Note.

Date: **14.10.25 - 12:30pm.**

Title: **Glebe Farm Discussion. Steyning Centre.**

Indicative technical illustration of Number 43 boundary buffer.

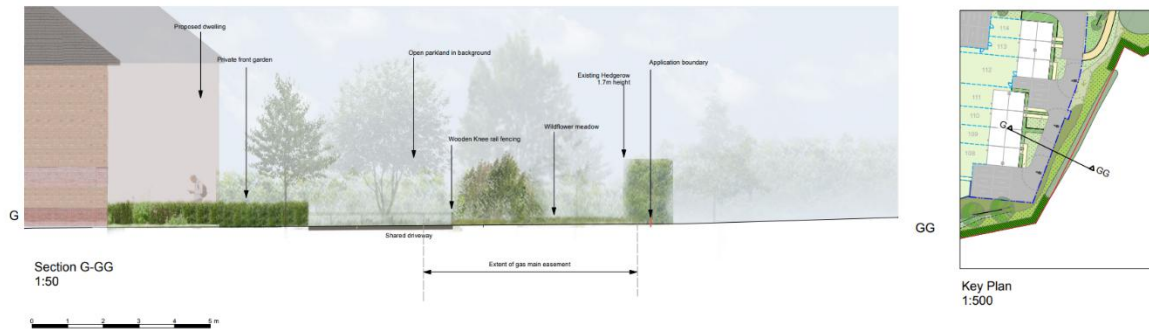
Post meeting note: the illustration should form part of these minutes. One being at no 43 Kings Barn Lane pinch point.

We agreed that the security gates at either end would not be required because it didn't need two lines of fencing due to the dense planting and that to illustrate this more accurately, at least 3 cross sections showing boundary design and planting would be provided.

VISTRY: We have pressed the utilities statutory undertakers to respond to technical constraints for planting request and provide clarification on what is permissible for planting schedules on the easements and boundary. Once these have been provided

our landscape and technical team will issue further detailed plans and illustrations of these cross sections, which will be fully addressed at condition discharge stage.
